## **Planning and Zoning Commission Meeting**

<div>STAFF</div> <div>REPORT</div>
<b>Date:</b>	12-10-21
<b>Prepared By:</b>	Jack Hendrix
<b>Subject:</b>	319 E. Main St. – Smithville Townhomes Site Plan

# Smithville Townhomes

<div>STAFF</div> <div>REPORT</div>
<b>Date:</b>	12-10-21
<b>Prepared By:</b>	Jack Hendrix
<b>Subject:</b>	Smithville Montessori Academy Site Plan

# SITE PLAN

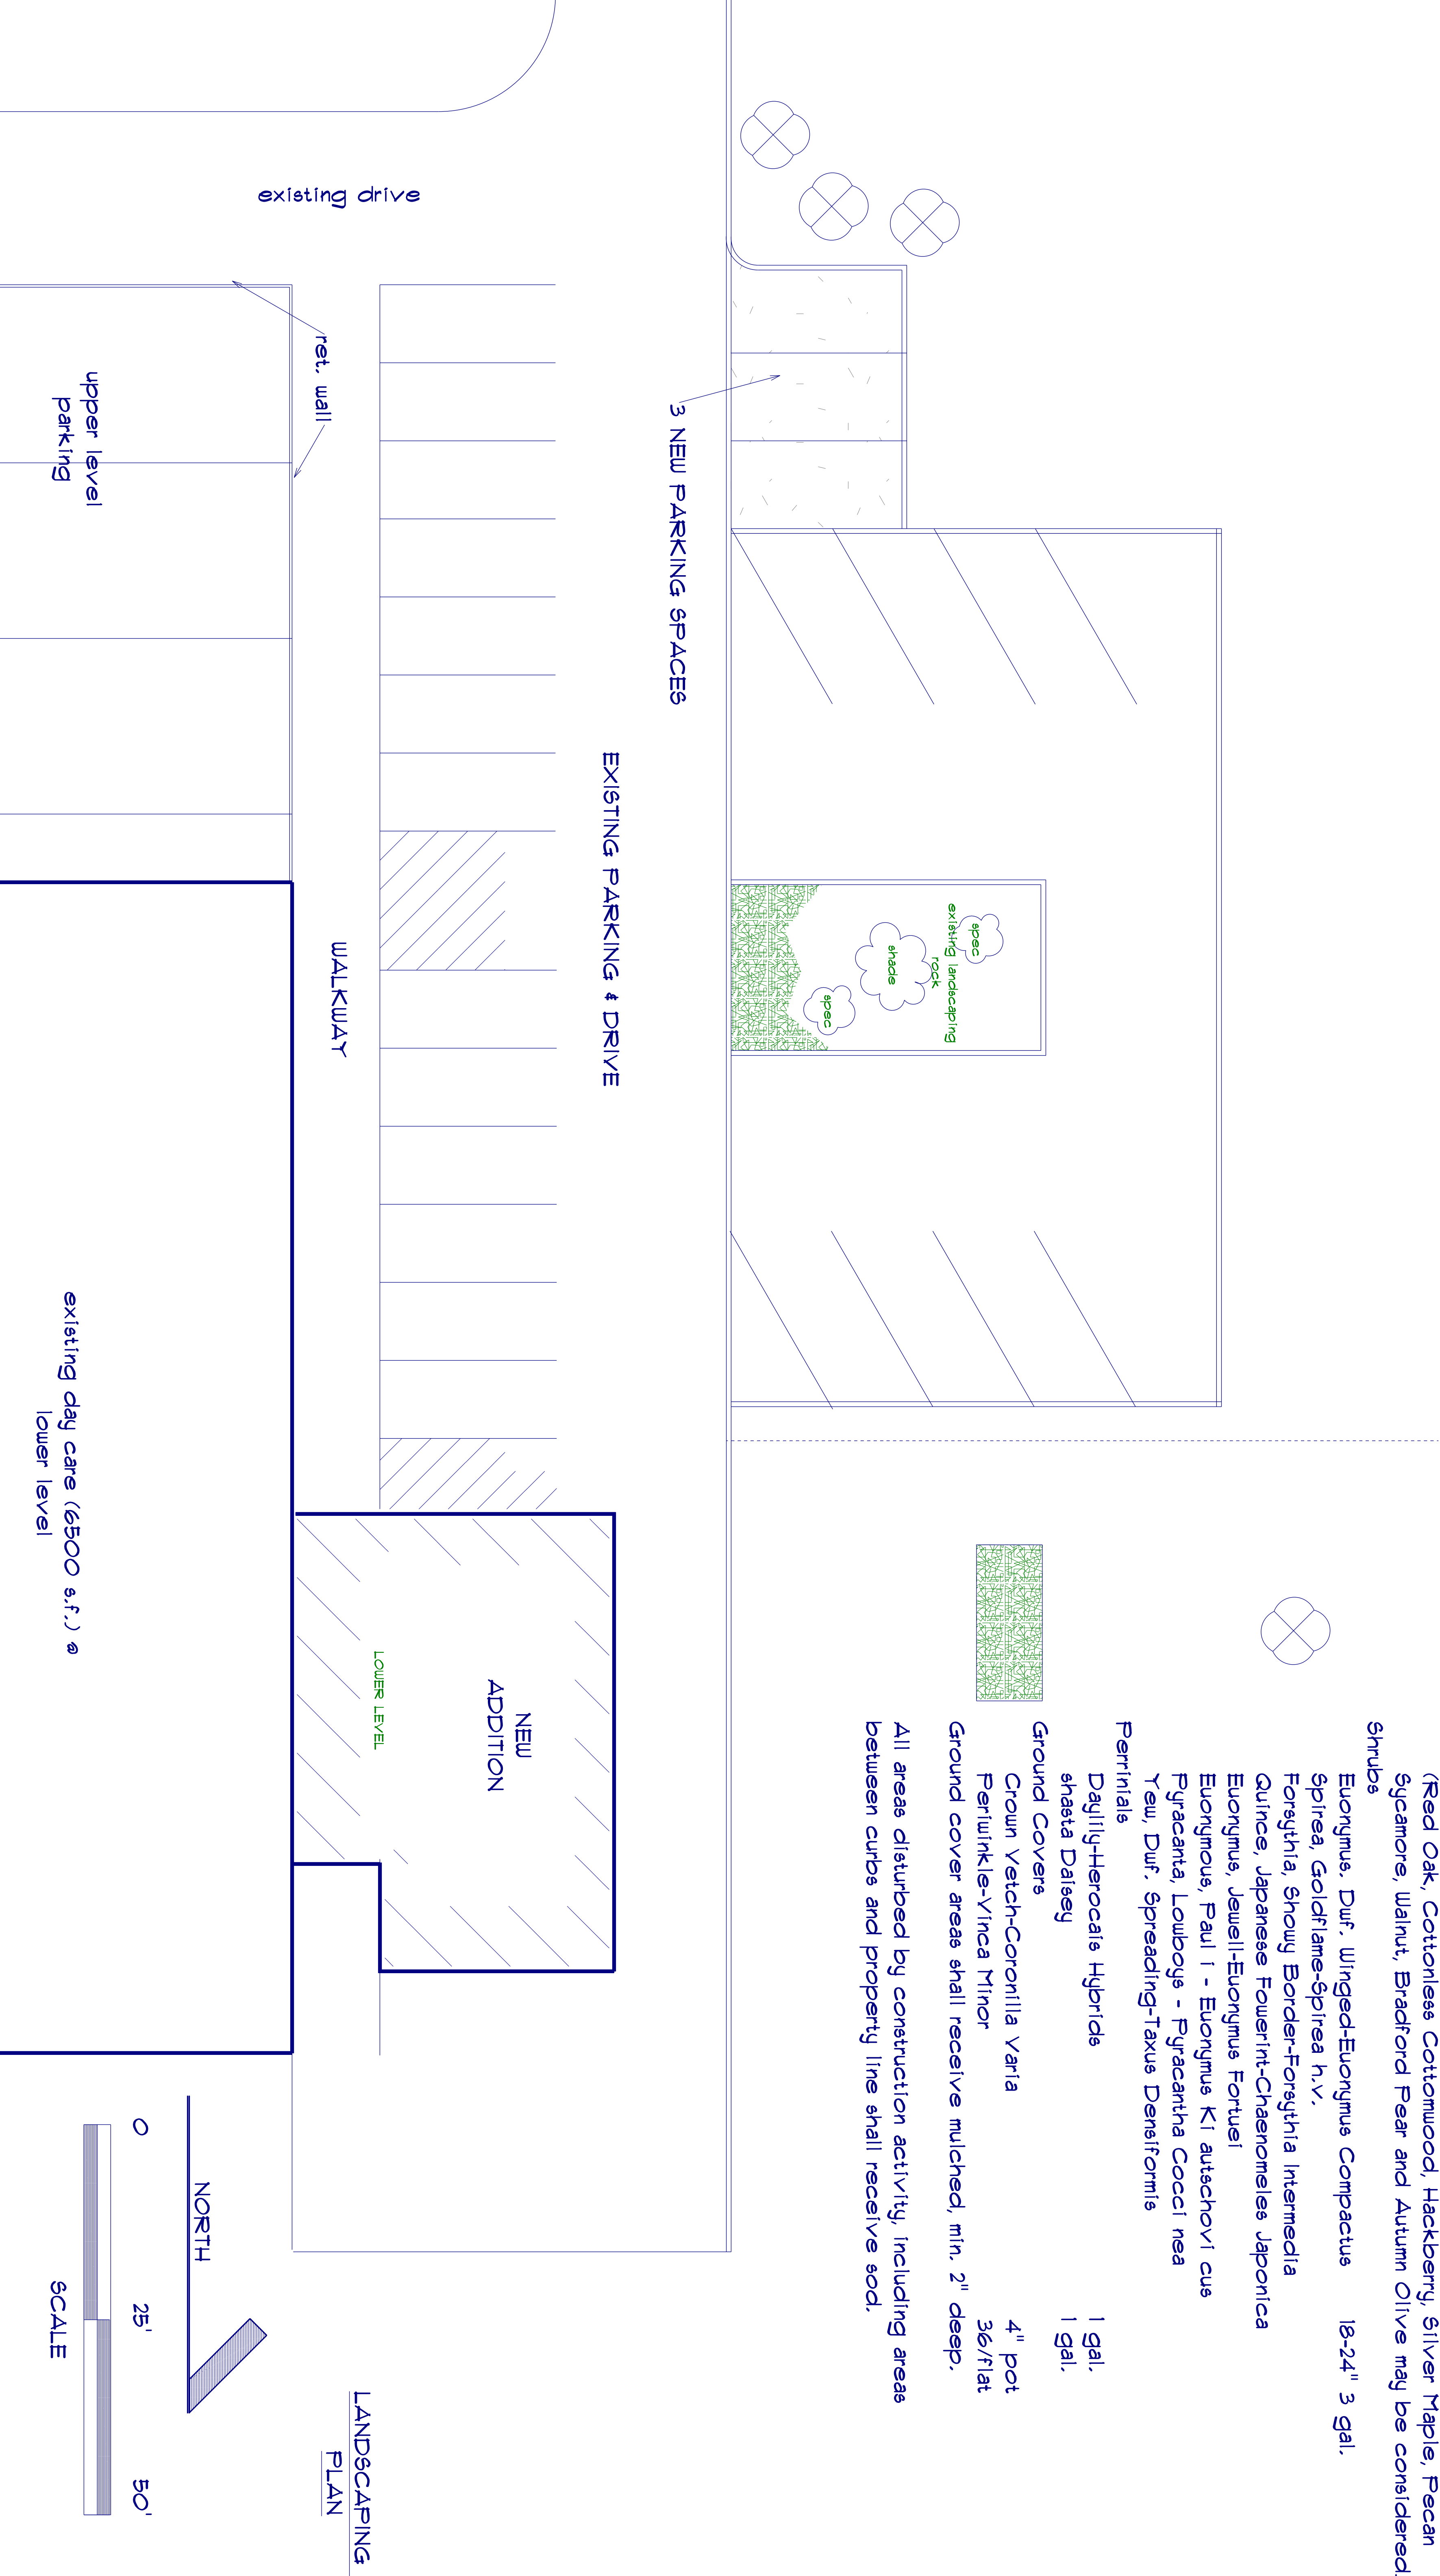
Applicant has submitted plans to make an addition to the rear of the Major Mall for expansion of its' existing daycare business. Since it is an expansion, the proposal is required to make the addition as cohesive with the existing structure as is practical.

To the extent that the construction will occur over existing paved areas, and the only additional areas of pavement will be a small area for three parking spaces, no adverse impact to the stormwater drainage will occur. The area will continue to drain naturally to the south over the existing vegetation and into the road ditch.

Staff recommends approval of the proposed additional in accordance with the plans. This approval is solely for the site plan portion of the project. The building construction plans will be subject to both City and Fire District review and approval and will require fire sprinklers in accordance with the Fire District requirements.

WEST ELEVATION  
SCALE: 1/4" = 1'-0"

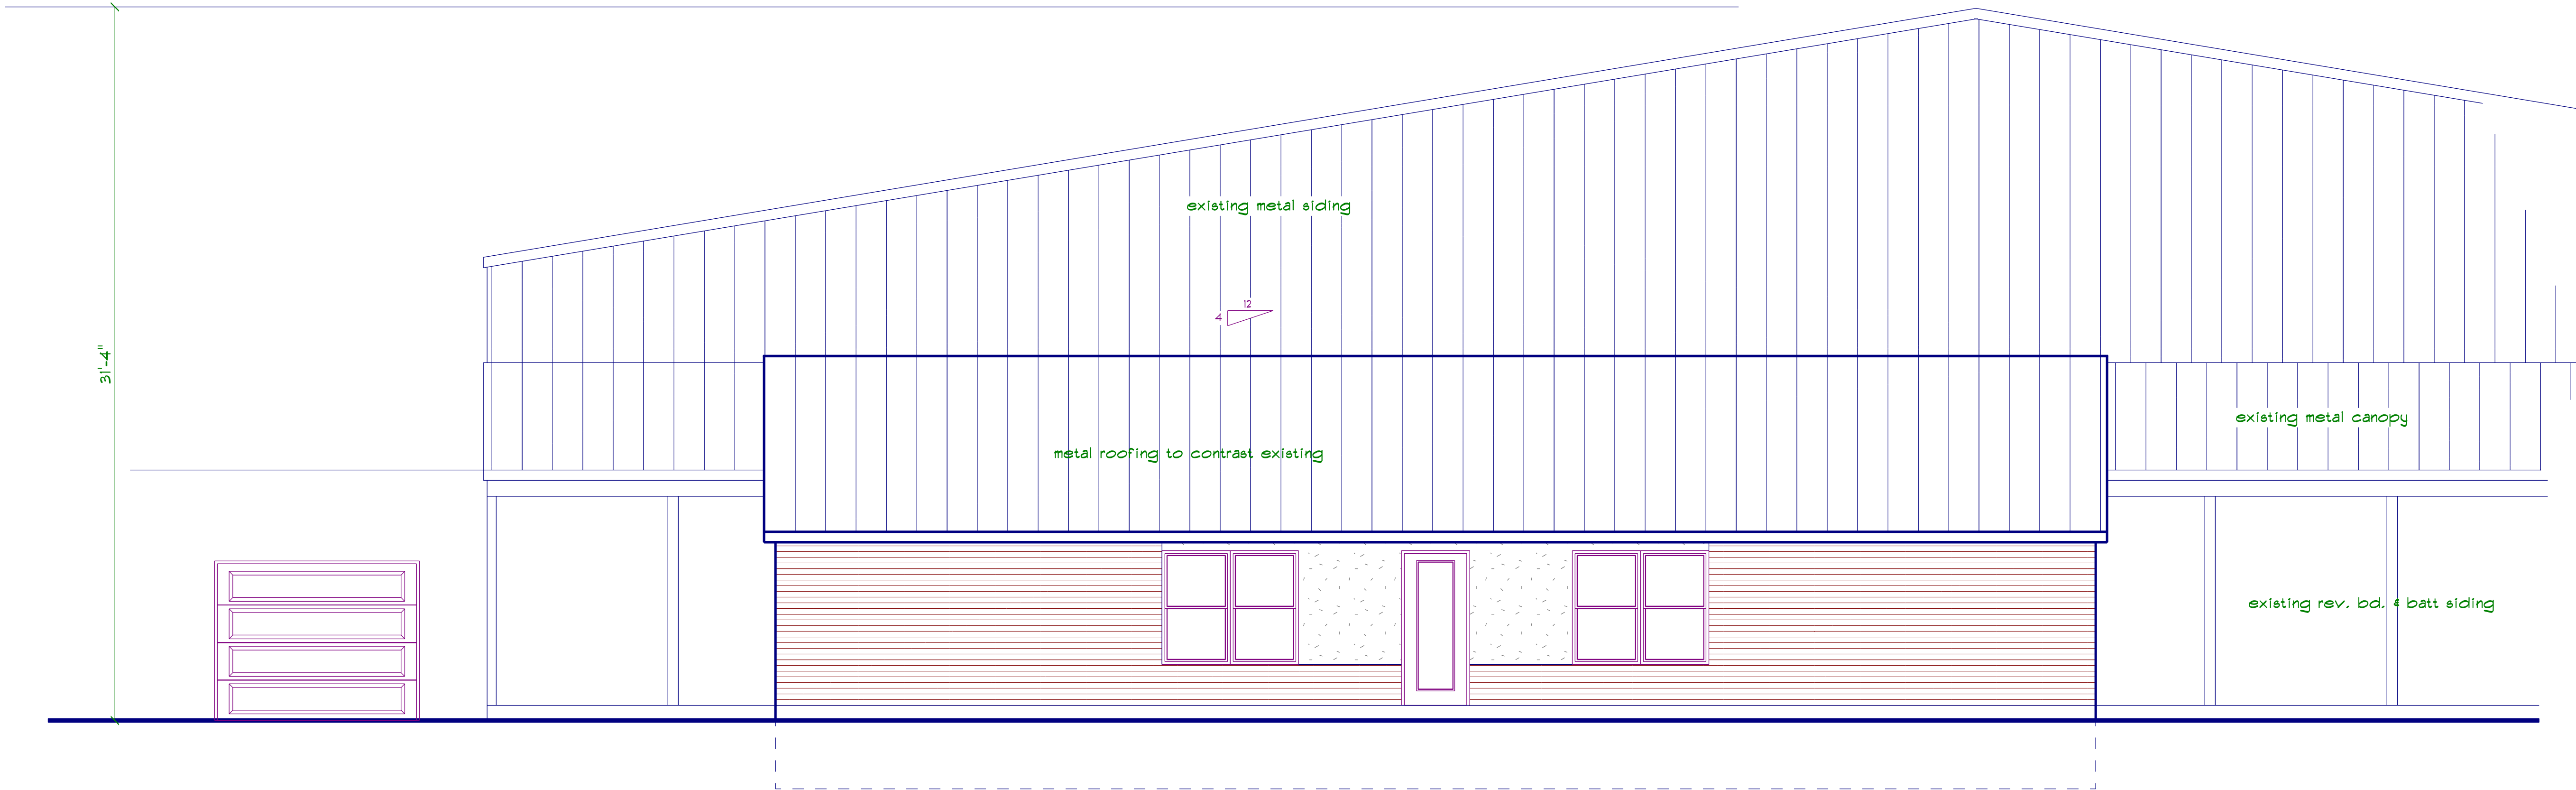
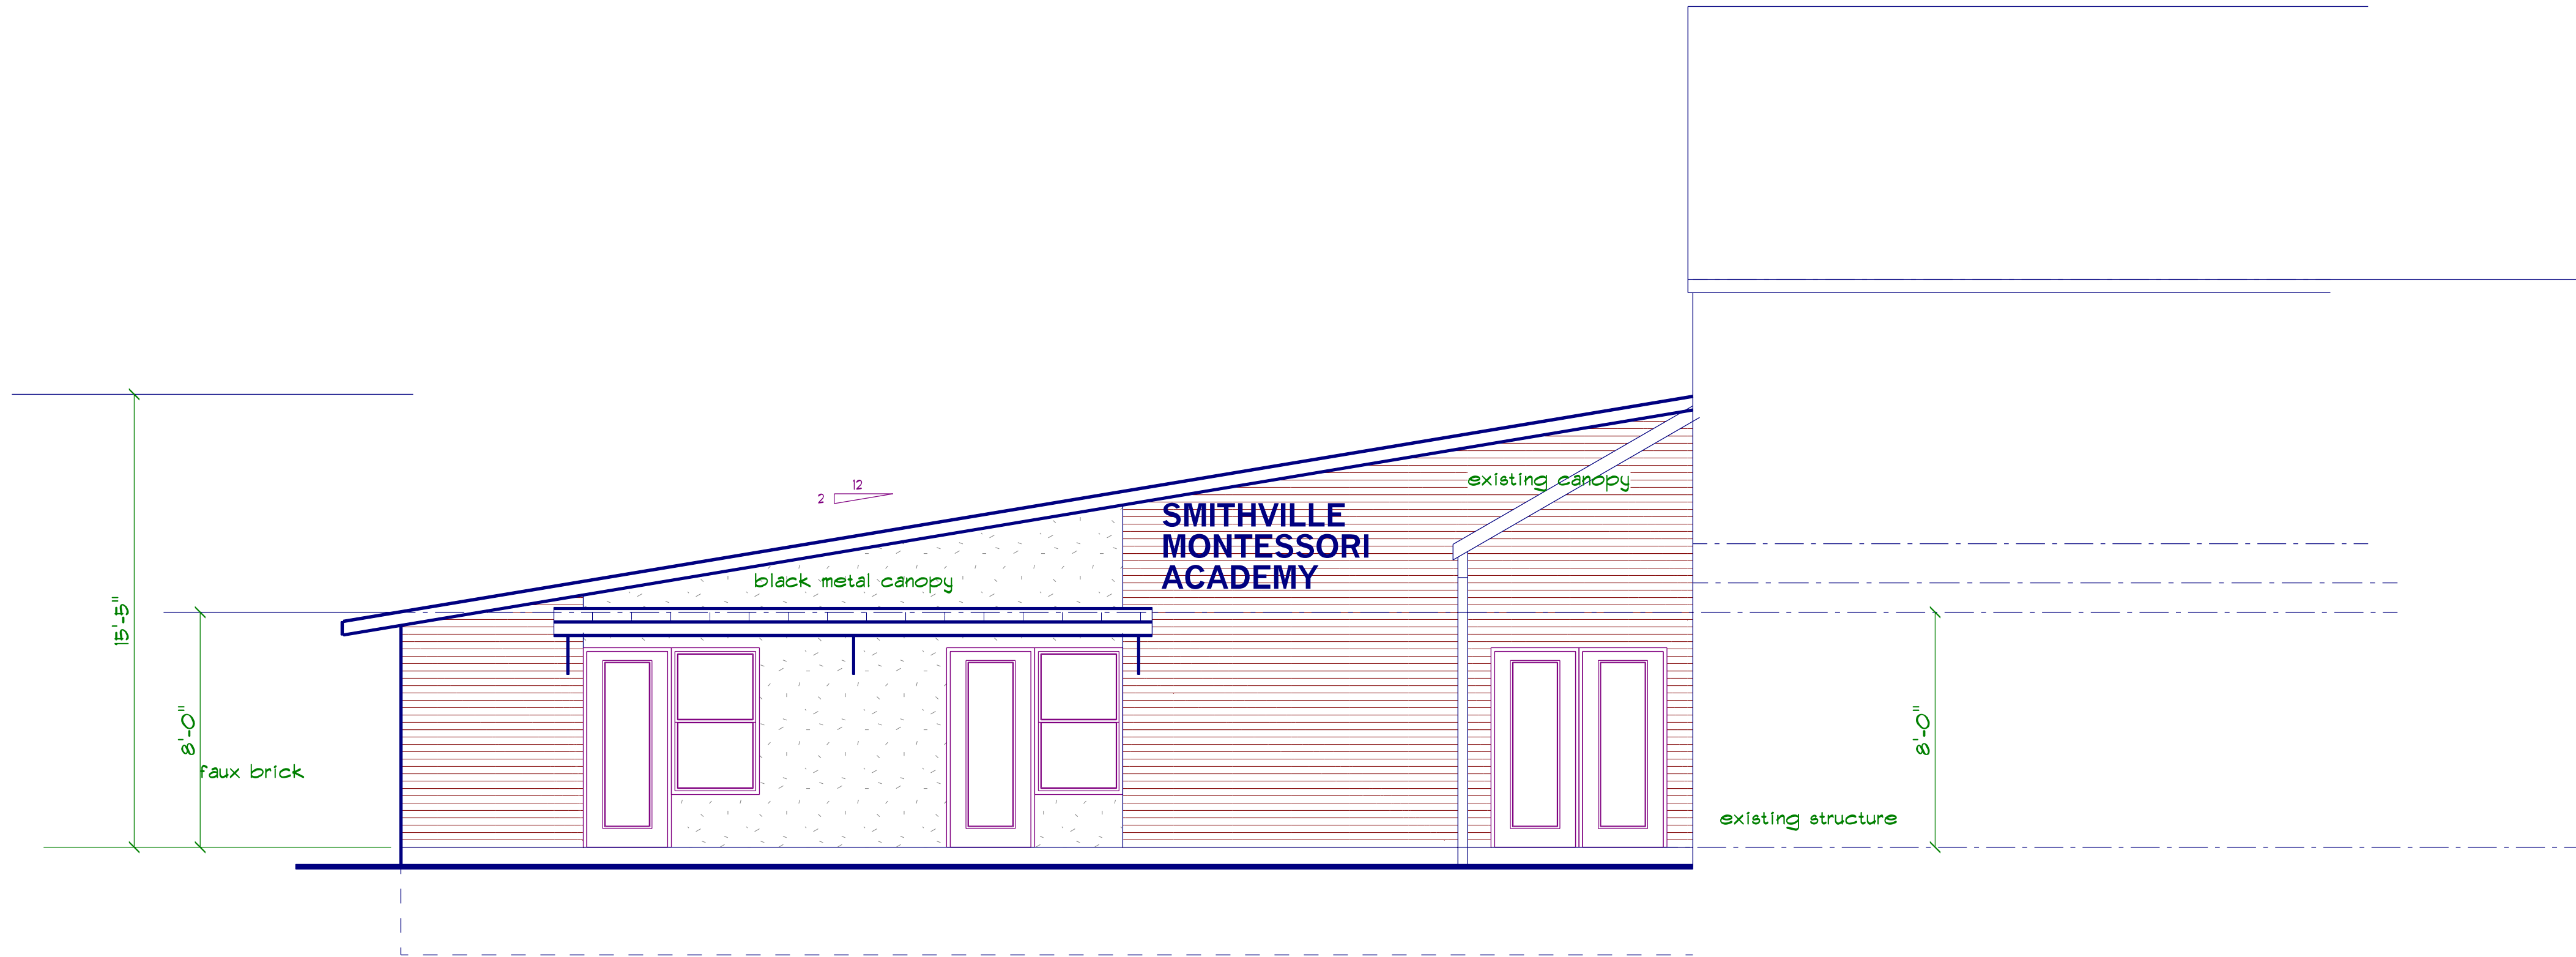
As shown on the attached plan sheets, the request is to extend the lower level out from the existing façade. The roof is proposed to contrast the existing metal on the roof and the second story façade, and the three sides of the addition to be clad with a faux red brick material. The entrance to the new structure will include a new canopy using black metal. The stucco areas will be beige colored.

In an addition scenario, the purpose of this review is to verify the addition will not bring the overall building/project out of compliance with the code. In this case, the contrasting style, material and color scheme actually upgrade the buildings' compliance with the code while still blending with the existing structure.
